SYDNEY CENTRAL CITY PLANNING PANEL

COUNCIL ASSESSMENT REPORT

Panel Reference	2016SYW247
DA Number	DA/1066/2016
LGA	City of Parramatta
Proposed Development	55-storey mixed use tower comprising 314 residential apartments, 260 hotel rooms with associated function/conference facilities, and 9 levels of basement parking; demolition of existing commercial building at 10 Phillip Street, part demolition and adaptive reuse of existing church hall buildings; and retention of church building. The application is Nominated Integrated development under the Water Management Act 2000 and the National Parks and Wildlife Act 1974. The application is to be determined by the Sydney Central City Planning Panel.
Street Address	2 - 10 Phillip Street, PARRAMATTA NSW 2150 (Lots 1 & 2 DP 986344 and Lot 1 DP 228697)
Applicant/Owner	Coronation Parramatta Pty Ltd
Date of DA lodgement	14 November 2016
Number of Submissions	Advertisement 1: Eighteen (18) Advertisement 2: Three (3) [1 new submitter] Total: Nineteen (19) unique submissions

Report prepared by	Alex McDougall Executive Planner, City Significant Development
Report date	18 June 2018

Figure 12. Flood Affection Map (light blue represents Probable Maximum Flood affected, medium blue represents 1:20 year flood affected, dark blue represents 1:100 flood affected)

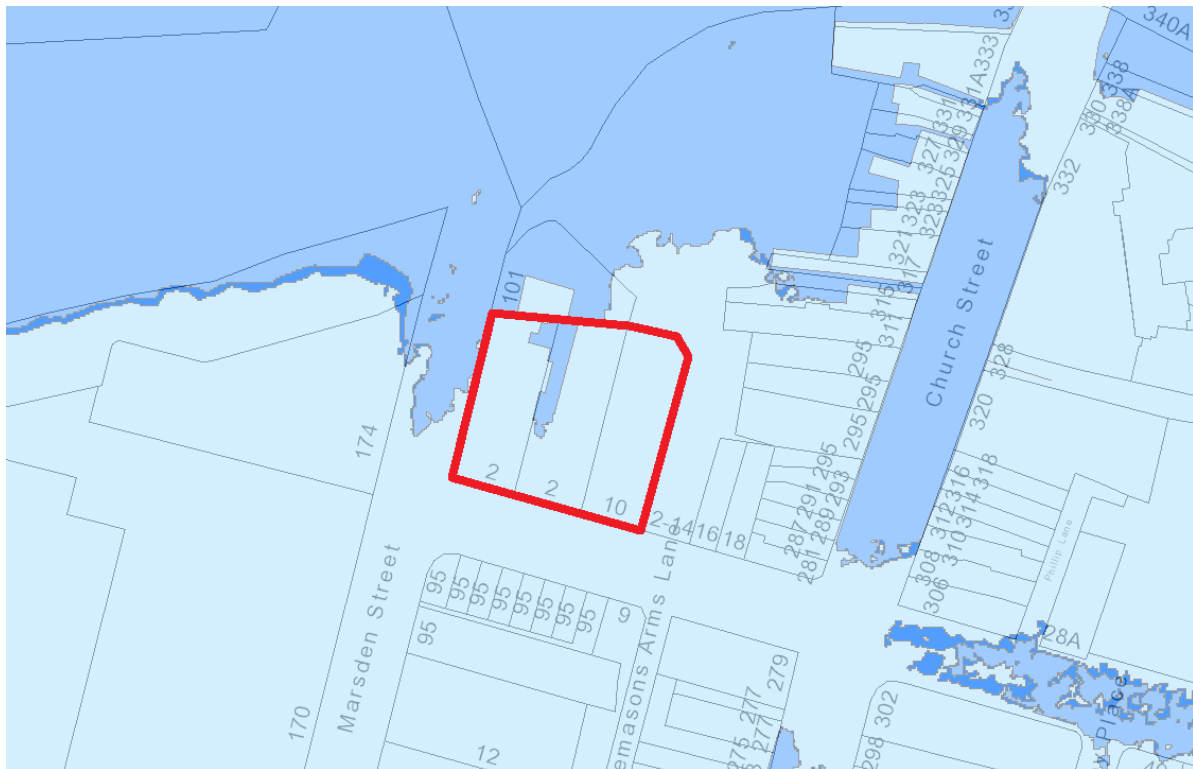
The site is subject to flooding, primarily from the Parramatta River but also from overland flow in the CBD (see Figure 12 above). The adopted 1:100 year flood planning level for the site is 9.0m AHD. The ground floor and driveway crest have been designed to be protected to this level. The vehicular access is located on the lesser flood affected side of site which is also desirable.
